SEWAGE DISPOSAL SYSTEM

DEPARTMENT OF HEALTH AND MENTAL HYGIENE

SUBDIVISION Braeburn LOT 3/4 Combined ROAD 10825 Braeburn Road

FILE INQUIRY FORM

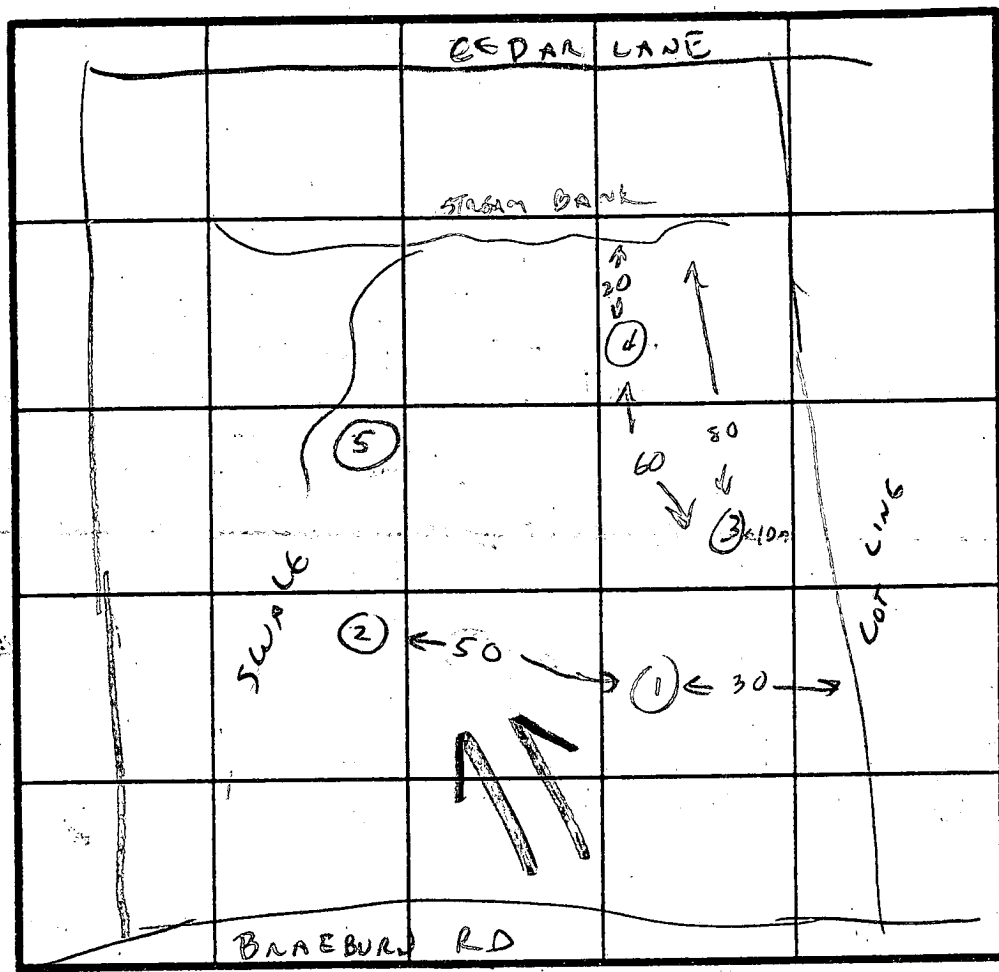
LIMITED AREA OF ACCEPTABLE SOILS, PROPERTY PLAT SHOWING ALL RELEVANT DETAIL INCLUDING TEST HOLES, WELL SITE, B.R.L., STREAMS & SWALES REQUIRED BEFORE DECISION. (CW)

TYPE OF SOIL SAND LOAM SOIL, LIMITED AREA DUE TO DRAINAGE SWALE & STREAM

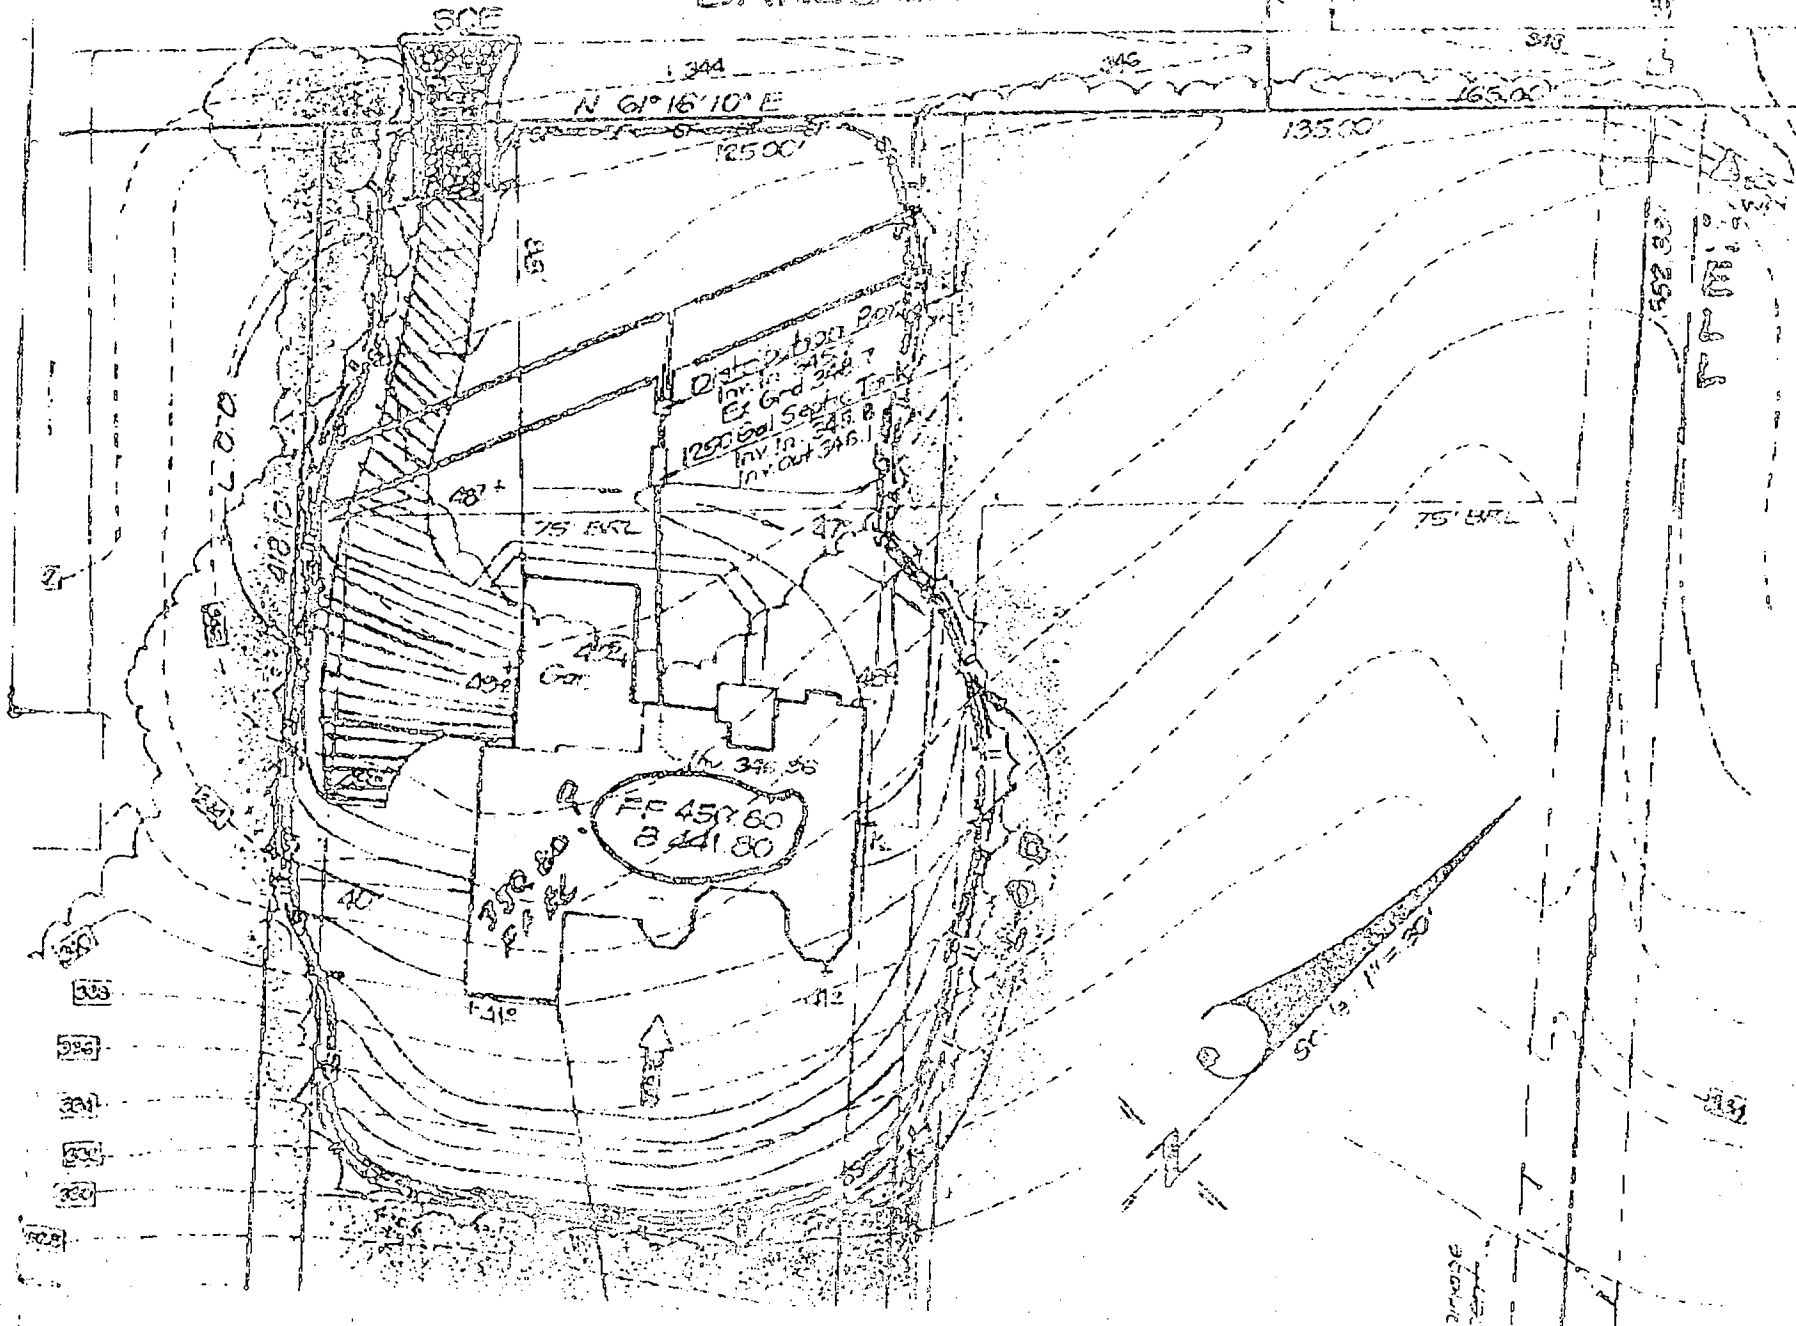
Because of the driveway - the entire ~~system~~ drainfield system needs to be under the driveway. Also invert into trench is 2.0' below grade. The house may need to be raised to provide 18" cover on house sewer connection Please revise and resubmit plan

Total of SIX 50 foot trenches

**HOUSE LOCATION
DRAWING**

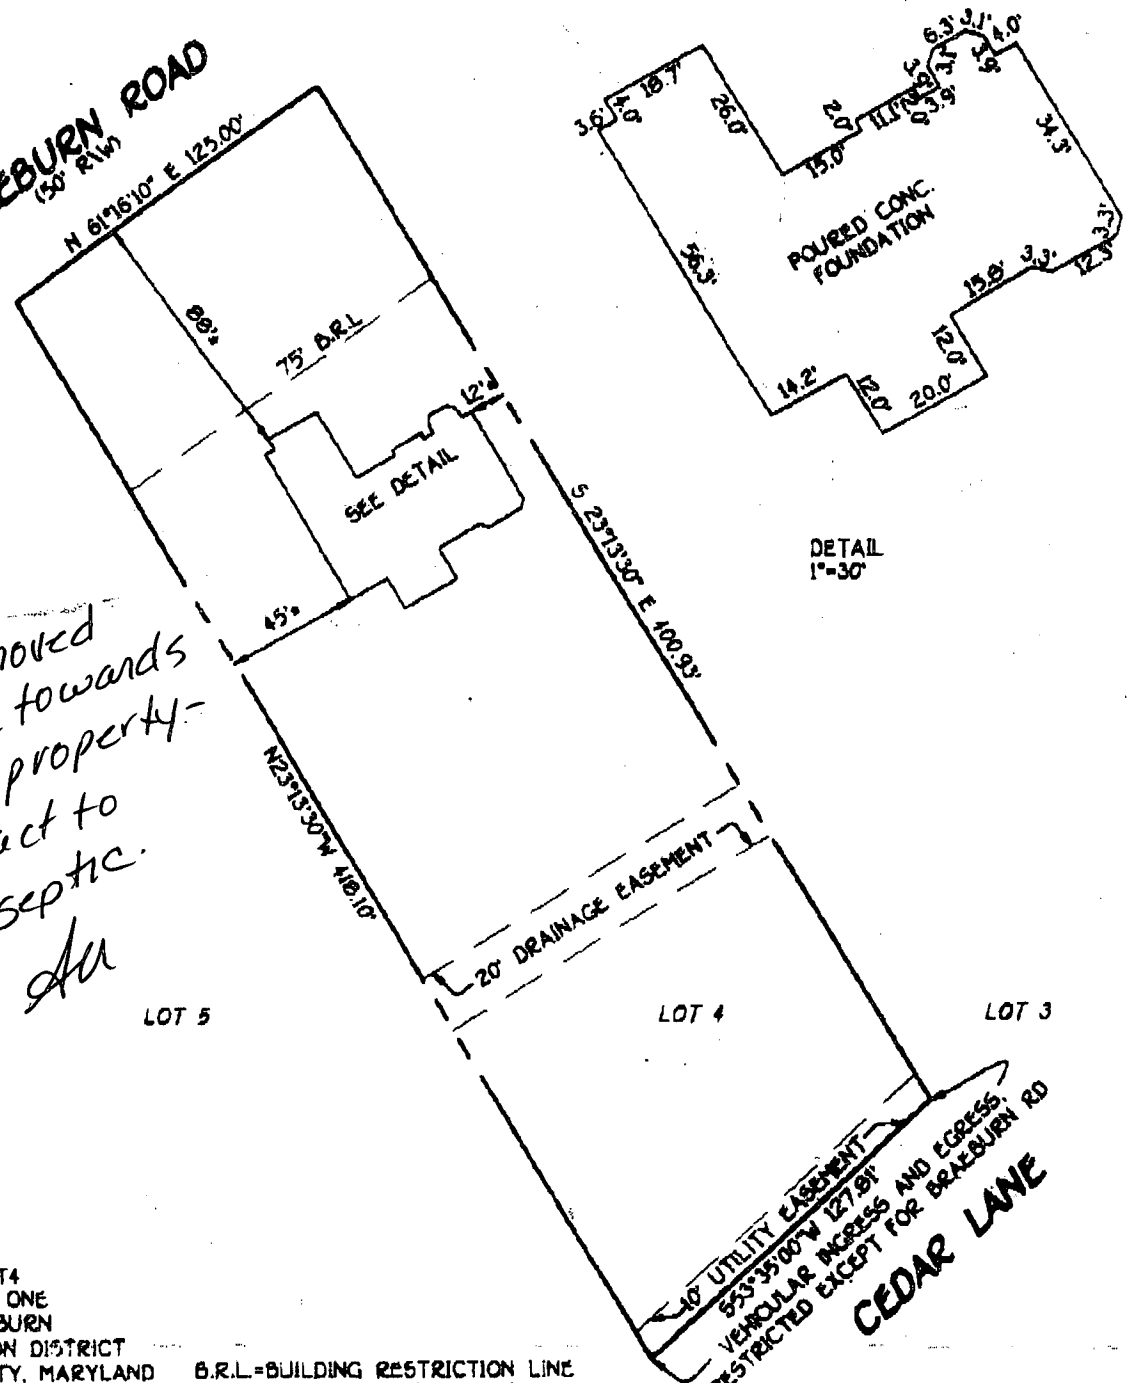
7/12/00
House moved
10' back towards
rear of property -
No impact to
well or septic.
AK
